# Technical Bulletin 6

## Guidance On Webbing Handrails Located Along Climbing Inclines On Inflatable Play Devices (slides)

Technical Bulletin:	6
Title:	Guidance on webbing handrails located along climbing inclines on inflatable play devices (slides)
Date:	November 2023

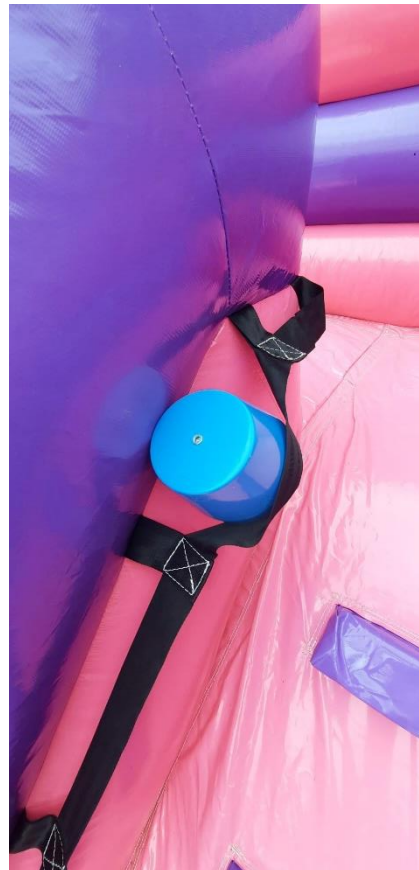
The inspectors found that the spacing between the stanchions allowed enough free play for the small head probe to pass between the webbing and the PVC panel to which it is attached. But would not allow the large head probe to pass through the same gap.

1. As per section 4.2.5.2 there are multiple completely bound openings created by the webbing handrail/banister and these have the potential to create a head and/or neck entrapment.
2. When considering the photographic evidence presented to the GCG these openings do form a head/neck entrapment when applying the requirements of sections 4.2.5.2A and D2.1.
3. Section 4.2.5.2 suggests an allowance for completely bound openings located on platforms with a lower edge less than 600mm above the platform on which it is located.

The webbing handrails/bannisters do not comply with BS/EN 14960-1 and do form a potential head, neck, or limb entrapment when all relevant sections of the standard are considered.

1. For future products, manufacturers could simply increase the number of stanchions tying the handrail back to the unit until the opening no longer allows the entry of the small head probe. The GCG would not recommend expanding the opening to allow the large head probe to pass through as the location of the opening on an incline would still present an increased risk to users.

2. The additional stanchions could be retro installed; however, this would be a complicated and costly solution.
3. The handrail could simply be removed. However, before doing this, manufacturers, inspectors, and repairers should carefully consider the risk to users should they slip or fall. Is this hazard significant in comparison to the risk presented by the handrail?

4. The handrail could be segmented to produce “Tabs” to which users could hold onto while climbing the incline. Of course, this would increase the strain associated with each “Tab” and may lead to seams failing earlier than expected.
